# **APPENDIX T**

## ***Responses to Comments***

# Comments and Response to Comments

**Table 1-1. Comments Received on the Sapphire Solar Project Draft EIR**

Figure 1. Locations of Easley Solar Project, land ownership, and access routes.

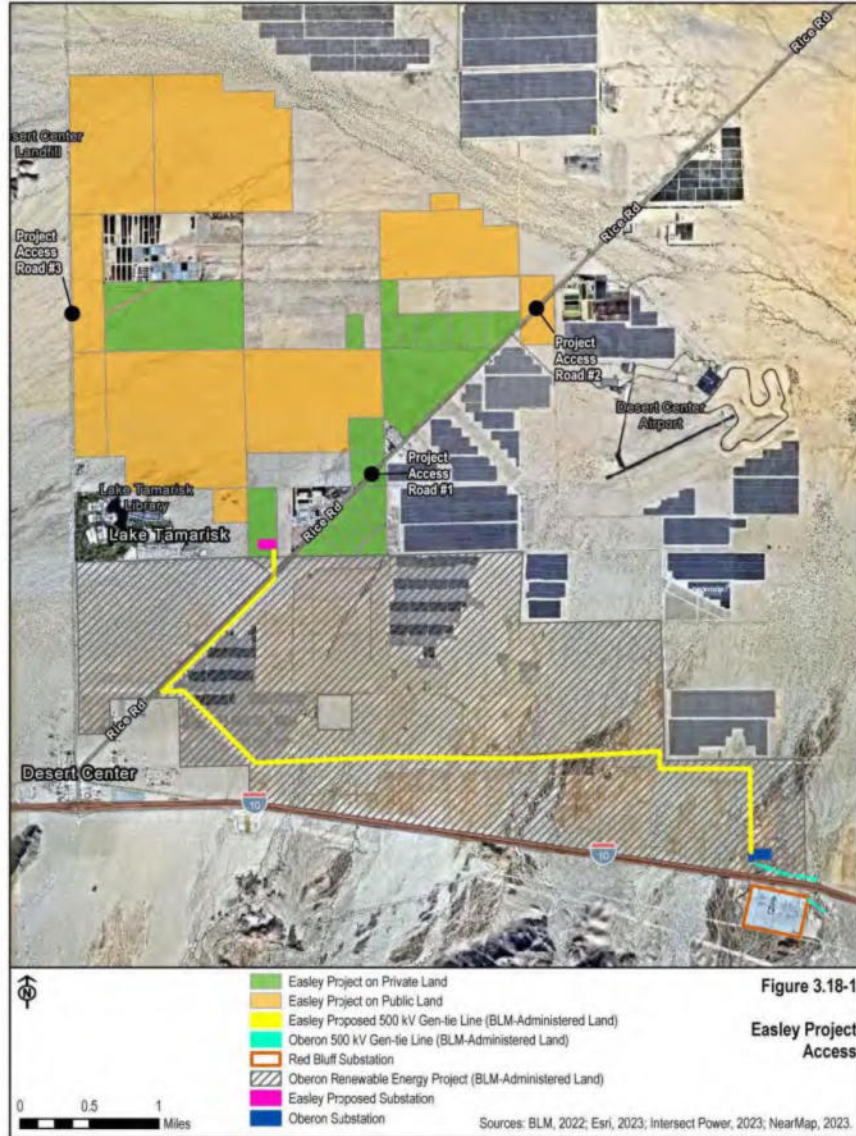
The proposed project is located in Riverside County near the community of Desert Center and in the Colorado Desert Recovery Unit for the Mojave desert tortoise. Elevations at the project site range from approximately 800 feet (244 meters) amsl in the southwest and 550 feet (168 meters) amsl in the northeast. The Chuckwalla Critical Habitat Unit and BLM Area of Critical Environmental Concern (ACEC), a Tortoise Conservation Area (TCA), abuts the western boundary of the project site and the Joshua Tree TCA is approximately four miles north of the project site (Figure 2).

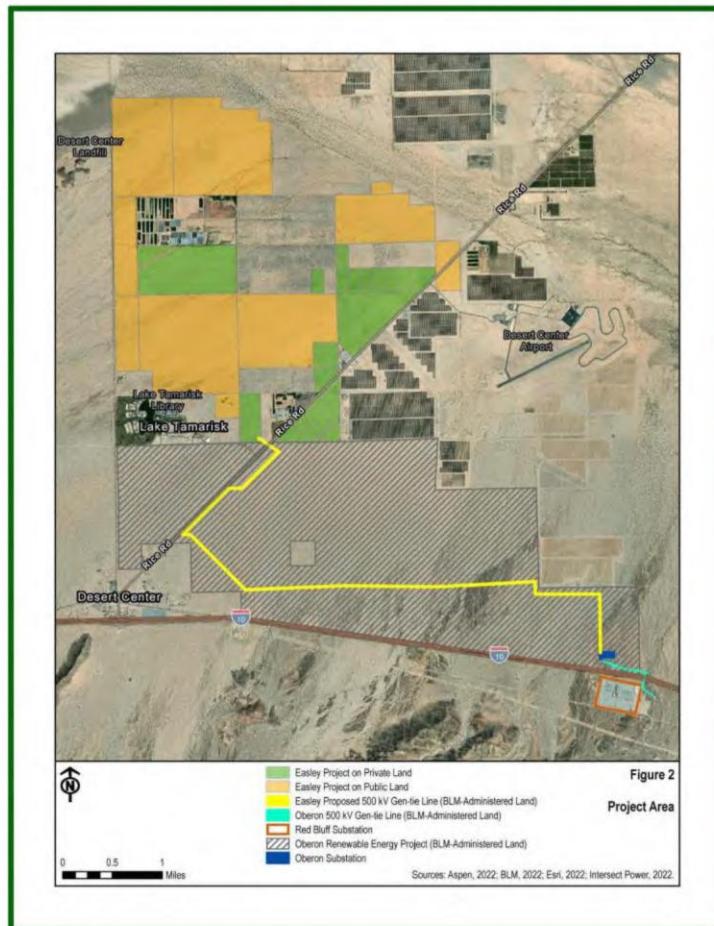
Both Figure 1 and Figure 2, below, show the exorbitant amount of solar development in the region:

Figure 2-4 (East Riverside Solar Projects & DRECP Context) and Figure 3.1-1 (Cumulative Projects) in Appendix A of the Draft EIR depict the locations of existing and proposed solar development projects and transmission lines. The surrounding solar projects are also listed in the cumulative scenario described in Section 3.1.2 of the Draft EIR.

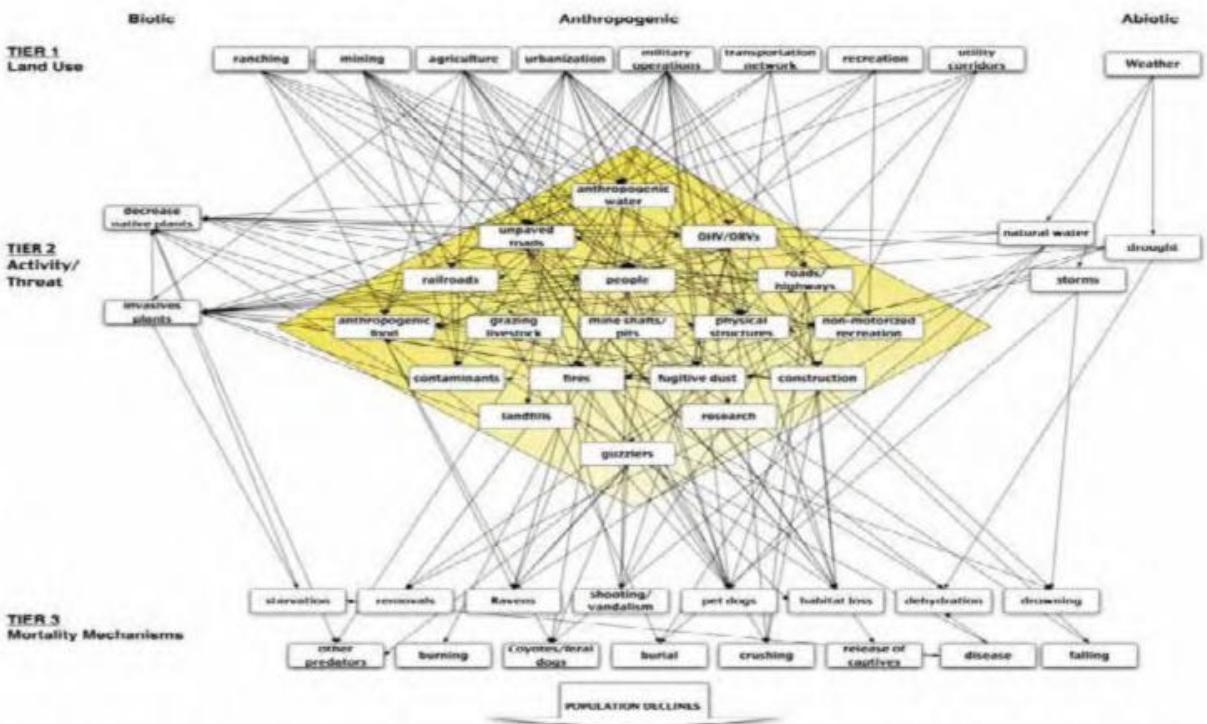
To help BLM understand the complexity of the cumulative and interactive nature of multiple anthropogenic threats to desert tortoise populations and to help develop BLM's analysis of cumulative impacts in the DEIS for this project, we have included a map of some of these multiple threats and their relationships to other threats (Tracy et al. 2004) (please see Figure 1).

Figure 4: Lake Tamarisk – a bird refuge

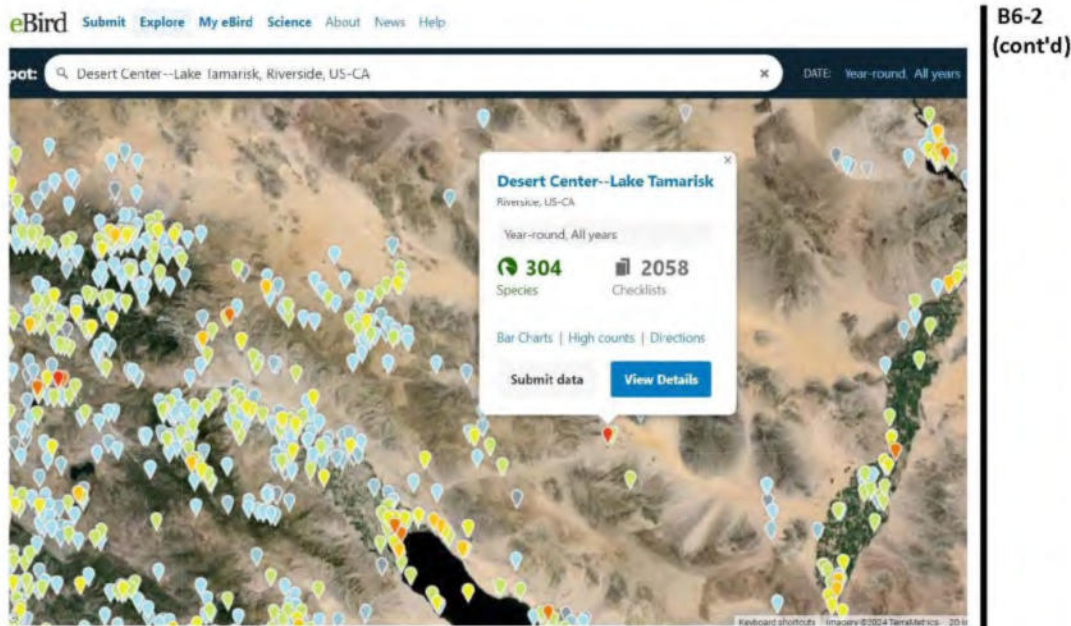
We have all learned that solar fields mimic water and attract birds, frequently to their death. Lake Tamarisk is a bird watcher's haven. We don't have to guess this value since Cornell University's worldwide checklist <https://ebird.org/hotspots> has the data. As of March 11, 2024, 304 species have been seen with checklists submitted by 2058 birders <https://ebird.org/hotspot/L419660>. Figure 1 below shows the strategic location of Lake Tamarisk on the 90-mile journey from the Colorado River to the Salton Sea. If there was a sea of solar panels only 600 feet from the boundary of Lake Tamarisk migrating birds looking for rest and refreshment could be confused and land on the panels (Figure 2). A mile buffer allows the surrounding ponds and the community's lawns, shrubbery, and trees to be seen by birds for landing and feeding (Figure 3).

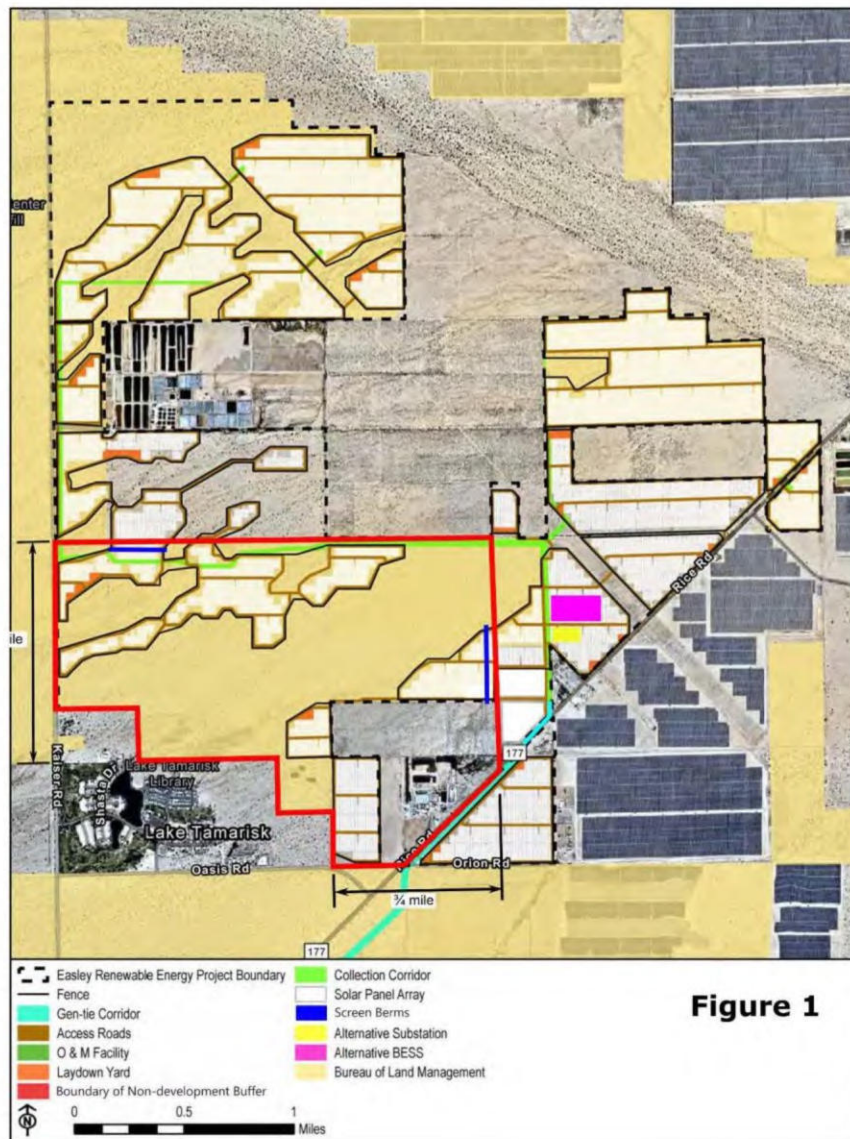
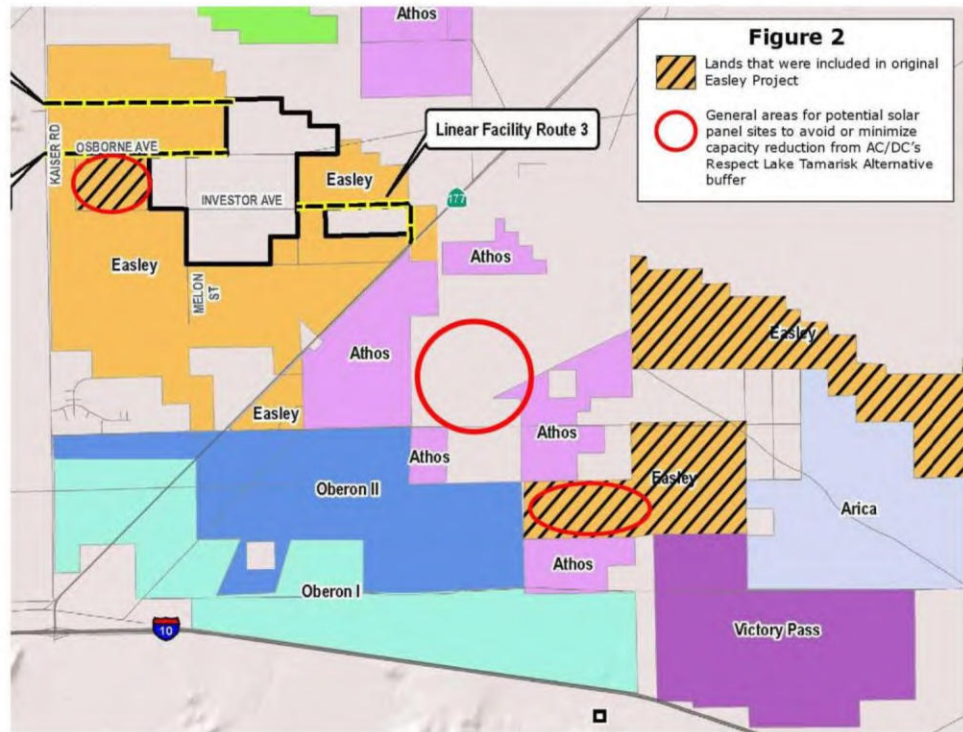
The central concept underlying the Respect Lake Tamarisk Alternative is that, as compared to the Lake Tamarisk Alternative, it provides for a substantially enhanced buffer between the Community of Lake Tamarisk and the Project.<sup>38</sup> This buffer varies between one mile and 3/4 of a mile, as shown by Figure 1, below. Figure 2, below, identifies three general areas, each including DFA or private land parcels (some with no habitat or degraded habitat due to earlier anthropogenic habitat modifications) not committed to existing or probable future solar projects. These and yet additional other lands included in the original Easley Project (Figure 2) present opportunities for Intersect to make up for the loss of solar panels in the enhanced buffer zone. We estimate the buffer zone in the Respect Lake Tamarisk Alternative to cut generation capacity by no more than 100 MW. Thus, even without making up for this reduction, the combined production from the Easley and the Oberon facilities will still amount to 300 MW + 500 MW = 800 MW (an average of 400 MW per project), that is, 88.88 % of 900 MW the two adjacent facilities would together generate if Easley's 400 MW capacity is not reduced.

Second, unlike the Lake Tamarisk Alternative, the Respect Lake Tamarisk Alternative will avoid both solar facilities encroachments on and construction as well as operation-related disturbances in the site's largest concentration of Desert Dry Wash Woodlands. (Compare DEIR Figures 3.2 & 3.5.2.)<sup>40</sup> The proposed enhanced buffer zone is also host to most of the Project site's Desert unicorn plants (DEIR Figure 3.5-4), a perennial sensitive plant species with habitat values and ethnobotanical uses the DEIR fails to disclose.

Third, based on the model for the statistical probability of desert tortoise occurrence used by the DEIR drafters, the Respect Lake Tamarisk Alternative protects the Project site's most suitable Desert tortoise habitat. "Desert tortoise habitat has lower predicted occupancy levels in the northernmost portion of the Easley Project site (0 to 0.2) and increases toward the south, with the highest occupancy levels of 0.5-0.6 in the southwest portion of the Project site." (DEIR at 3.5-8; Figure 3.5-5.)

**Figure 2: Drawing SK-1**

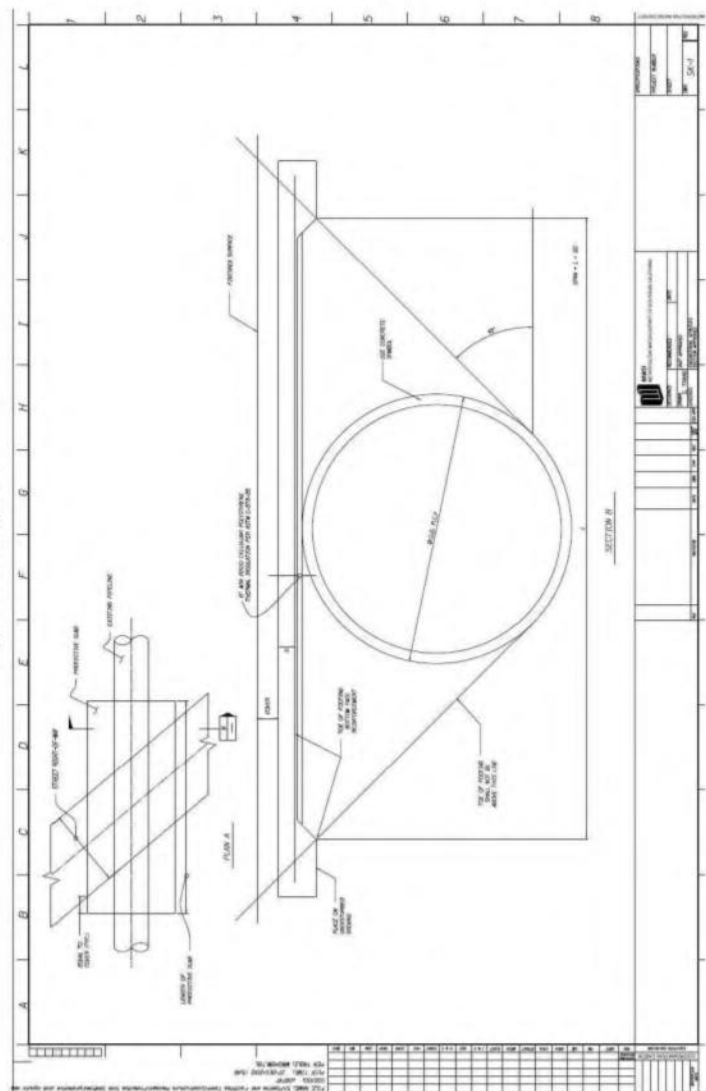
Protective slabs must be permanent cast-in-place concrete protective slabs configured in accordance with Drawing SK-1 (See Figure 2 on Page 22).
